We thank all the reviewers for carefully reading our manuscript and for the detailed feedback aimed at helping us to further improve the manuscript. Below we address the raised concerns in a point by point fashion. Changes are highlighted in the attached revised version.

This manuscript describes a multi-channel spectroscopic measurement system for the airborne detection of water vapor and total water content. The authors describe in detail the requirements for such a system, the setup characterization of their system, and example data from flight testing of their system. The manuscript has strong technical merit and represents a significant contribution to scientific progress. However, the manuscript suffers from some balance issues with respect to material, and the writing has some fluency issues. While I strongly believe this manuscript is ultimately worthy of publication, I recommend that the manuscript be returned to the authors and reconsidered after the address of some of the below issues.

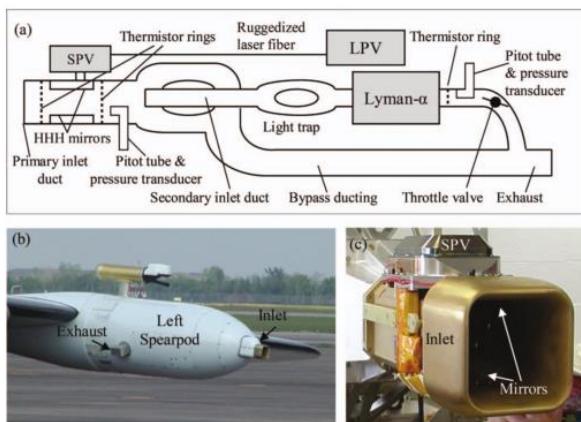
My major criticism concerns the total water channels. The inlet design parameters of 80 °C piping temperature and 100 liter/min flow rate (line 130) do not seem appropriate to ensure efficient conversion of condensed water to vapor prior to quantification in the closed-path cells. Any characterization of condensed phase sampling efficiency or comparison to other measurements during ESMVal would improve confidence in the accuracy of these measurements. If it is known that the total water channels have some inadequacies, this should be explicitly discussed at appropriate points within the manuscript, or alternatively, claims of multi-phase measurement capability should be tempered or removed.

Thank you very much for your comment. Total water vapor measurements using a forward facing inlet system (such as HAI) are not genuinely new – instead this is the standard method on aircraft. Depending on the exact payload, the installation in HALO requires a total $\frac{1}{2}$ " tubing length of 3-5 m, with several curvatures and rectangle L-connectors, flexible elements etc. This facilitates a lot of surface to gas interactions in the piping. The final gas temperature (before the air enters the instrument) is approximately 5-10 K less than the heated tubing temperature. What's more, it has to be considered for heat capacity deliberations that 100 liter/min at 100 hPa is “just” 10 std liter / min. In addition, HAI internally splits this flow in two(!) parallel heat exchangers (shown in the picture below) to avoid any temperature inhomogeneity (for spectroscopic reasons).

In other words, compared to other typical airborne installing/ instrument setups, HAI can ensure much better a full evaporation of all ice/droplets than others. If one even doubt that with a setup like HAI, other well established setups such as (Zöger et al., 1999) cannot prove it either – this would basically mean one doubts pretty much all extractive total water measurements. If such problems occurred at a high level it would be highly unlikely that the direct comparison of our open and closed channels yields such a good match after a cloud transect. If ice or liquid would not be evaporated completely it would quite likely build-up in the instrument and lead to long tails after a cloud transect, which we haven't found.
